FORCE Outboards

# service bulletin

No. 93-4

## Propeller Spacer- 1992 & Newer 90-150 h.p.

a. Propeller Spacer

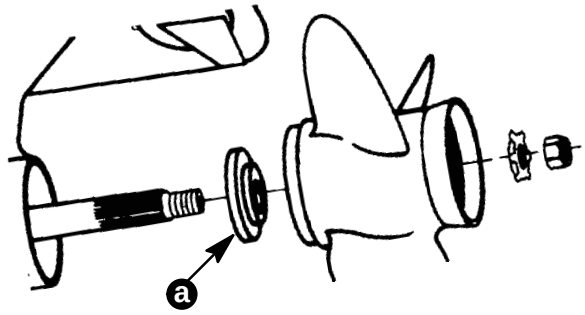
There is some confusion in the field regarding the use of the proper forward spacer (a) when installing a propeller on the Force 90 thru 150 h.p. Outboard motors.

The correct propeller spacer (b) to be used with the Mercury/Mariner (48- part number) designed propellers is 23-819057 pictured below.

Pictured below (c) is propeller spacer F698099-1, to be used with Force propellers beginning with “FP” part numbers.

d. Cardboard prop shaft shipping protector

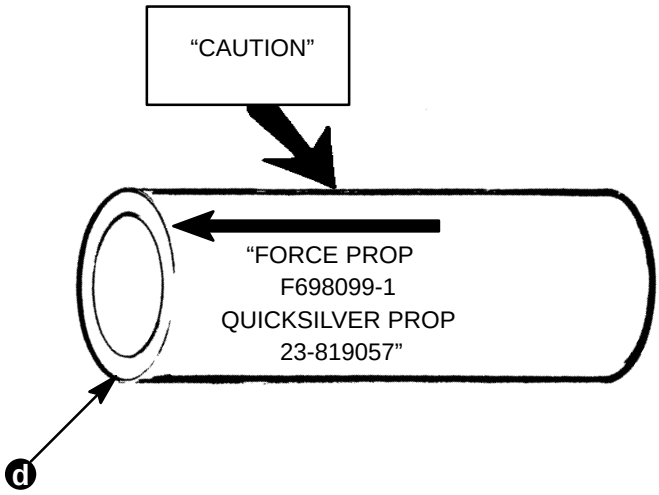
The cardboard prop shaft shipping protector, shipped with the engine, identifies both propeller spacers as pictured below (d).
